ADDENDUM NO. 2

DATE: April 13, 2015

Contract 14-C-00054; Blue Sink Water Main

Des:	JRD	W.O.	7410	File:	BLUESINK
Dwn:	PF	FILE NUMBER			
Ckd:	JRD	SHEET	6	OF	31

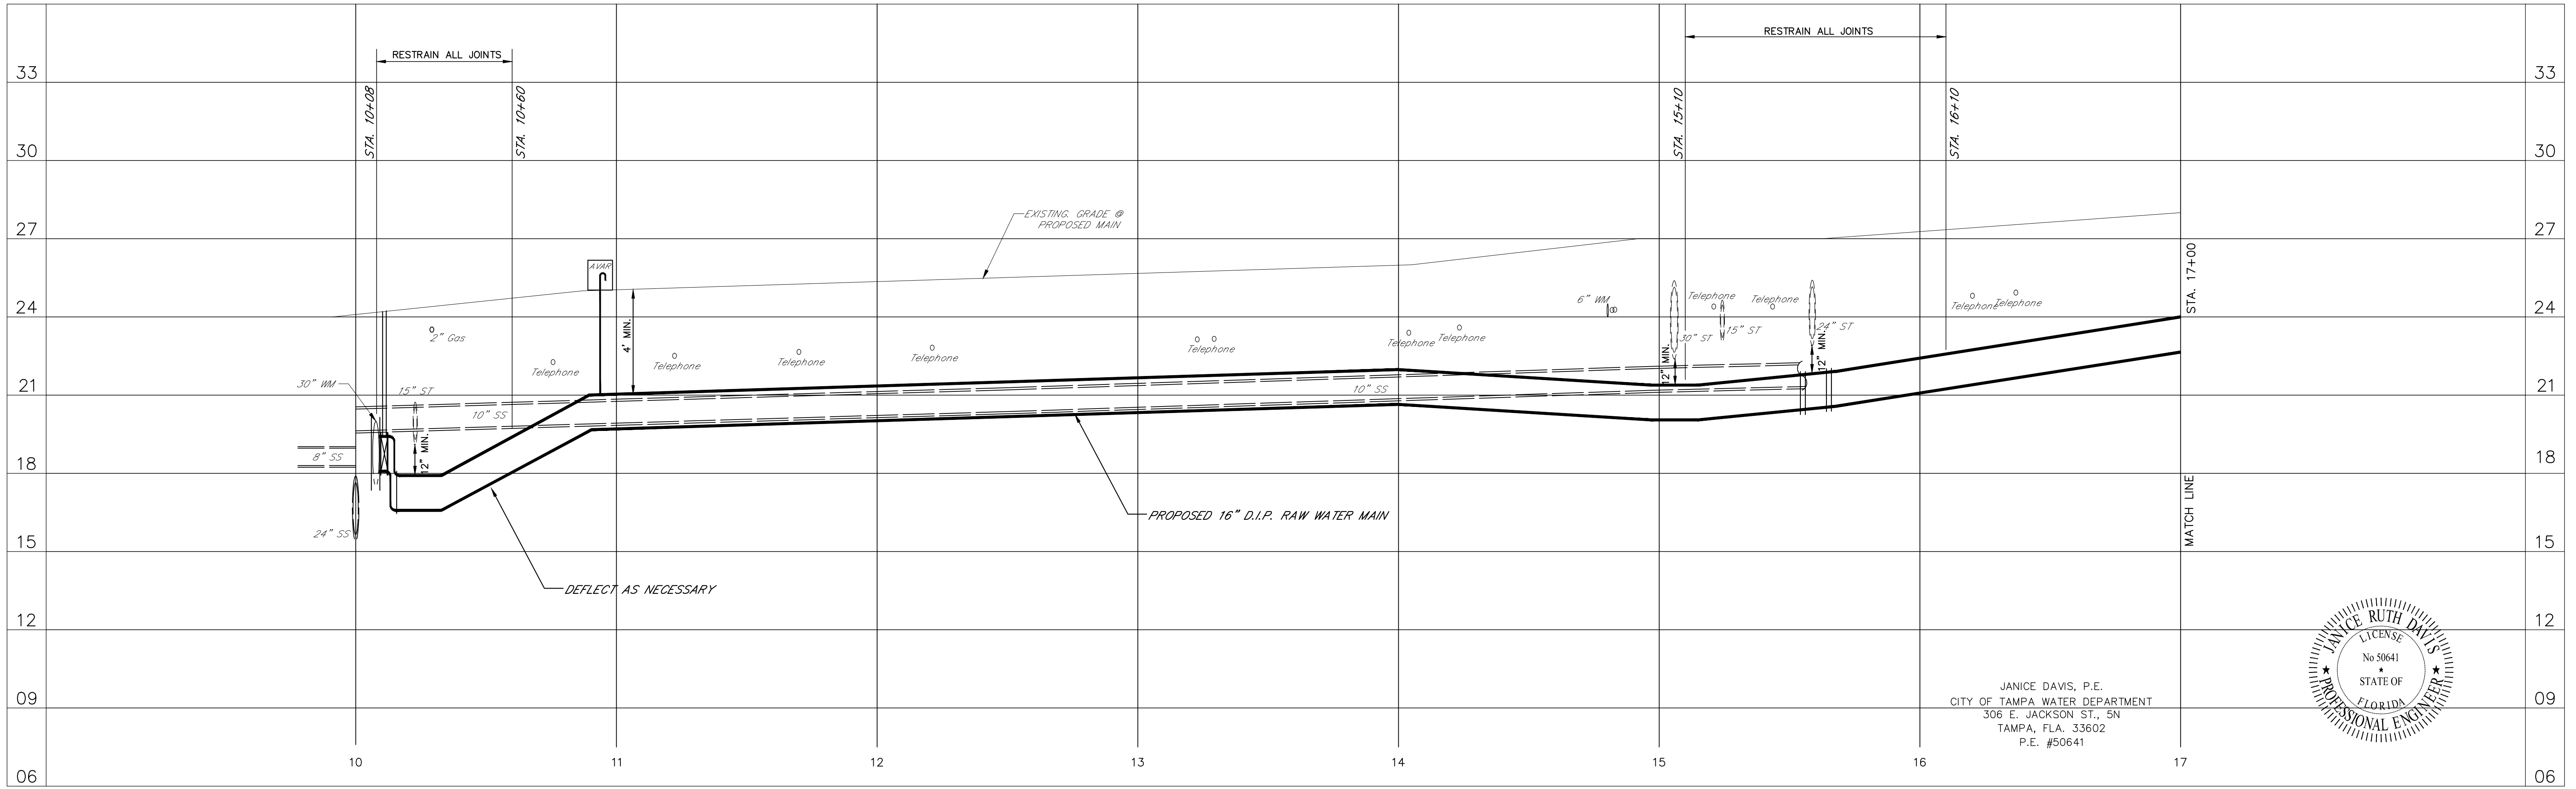
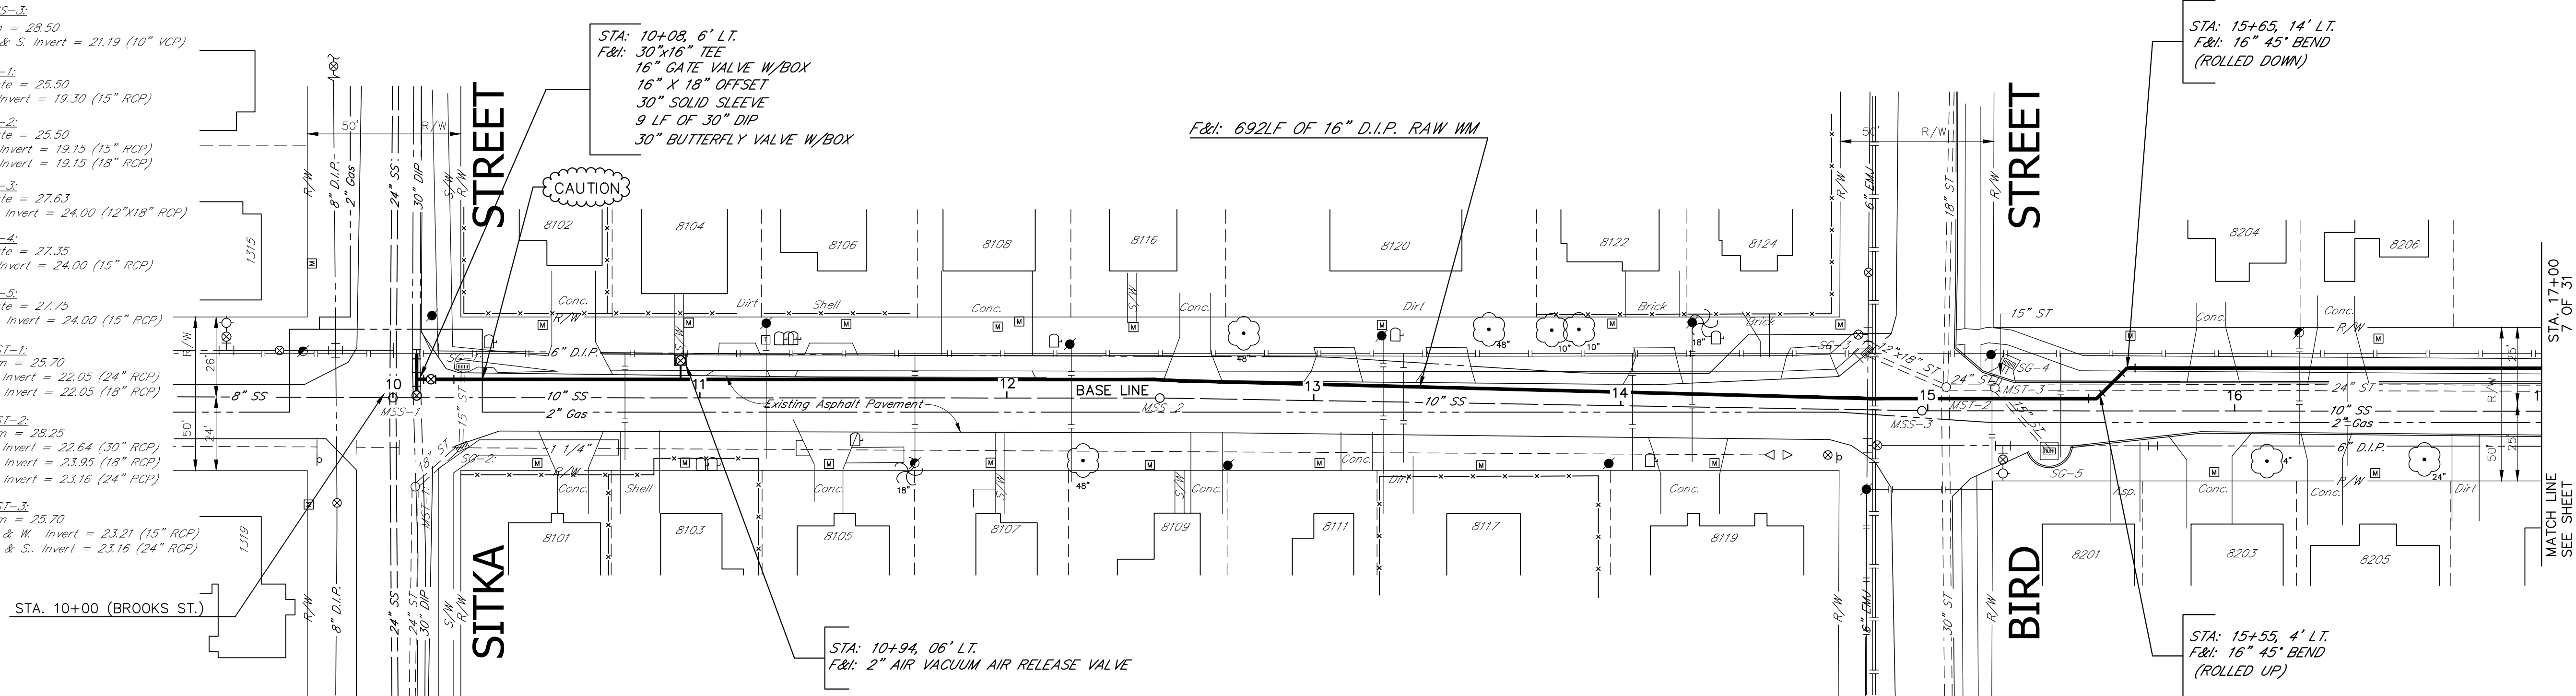
Atlas Page	C13-3				
	D13-4				
No.	1	Date	4/9/15	ADDED S/W, D/W AND PHONE CABLE	PF
By		REVISION			
Approved		Date

SHEET 11 OF 31

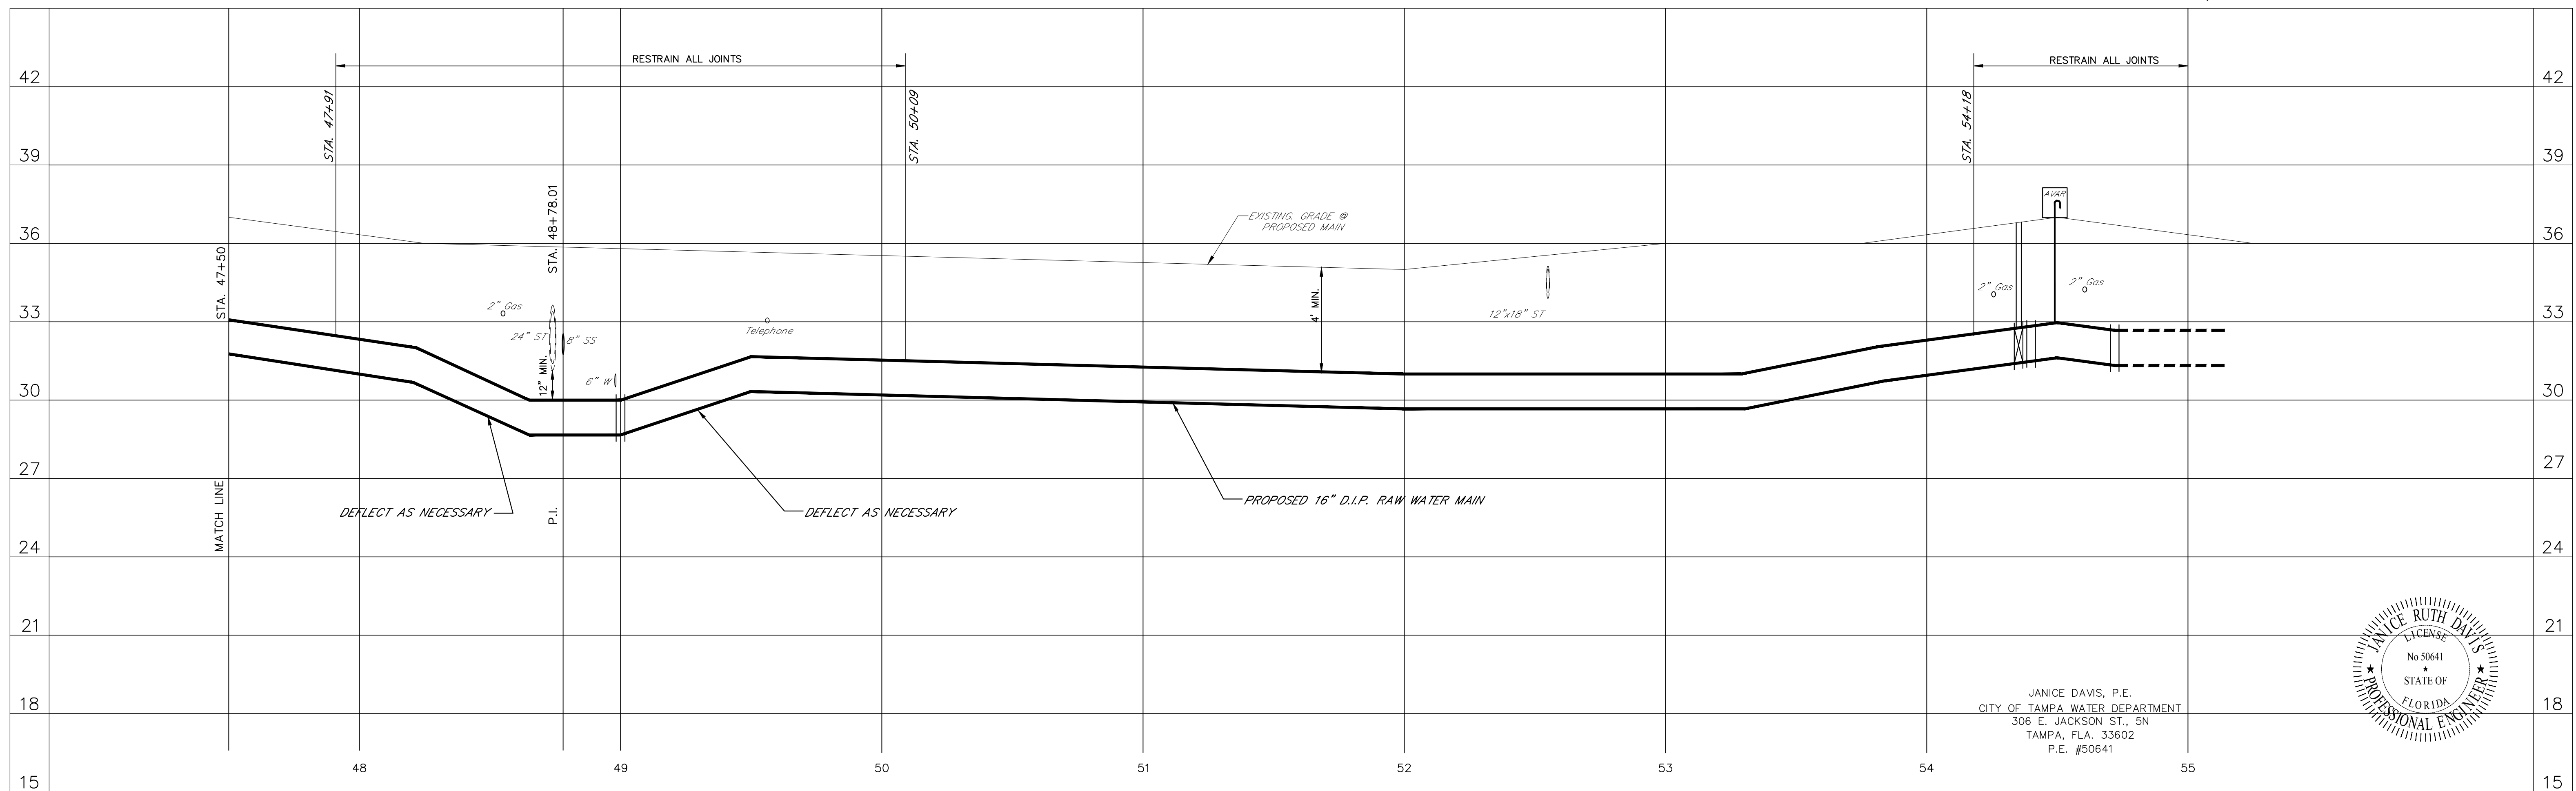
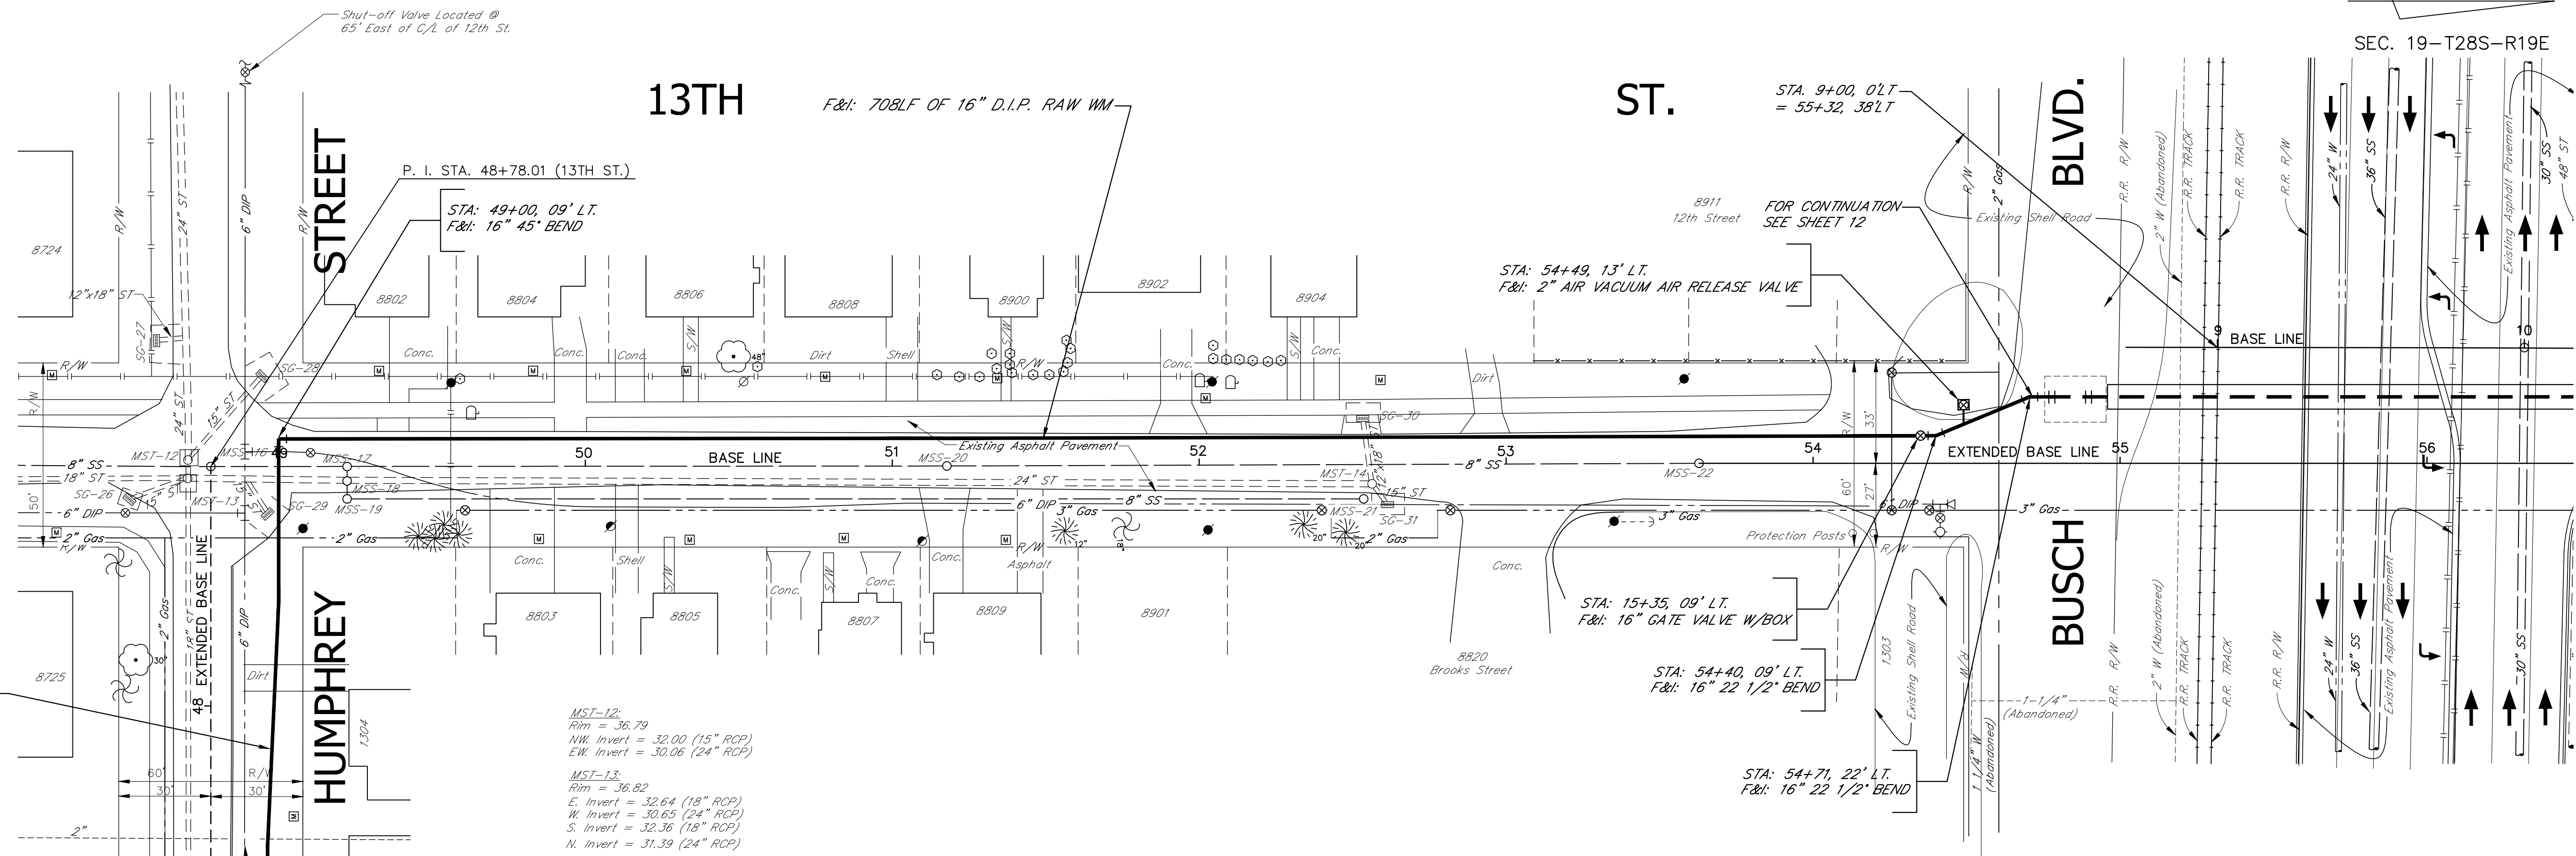
No.	Date	REVISION	By
1	4/9/15	ADDED PHONE CABLE	PF
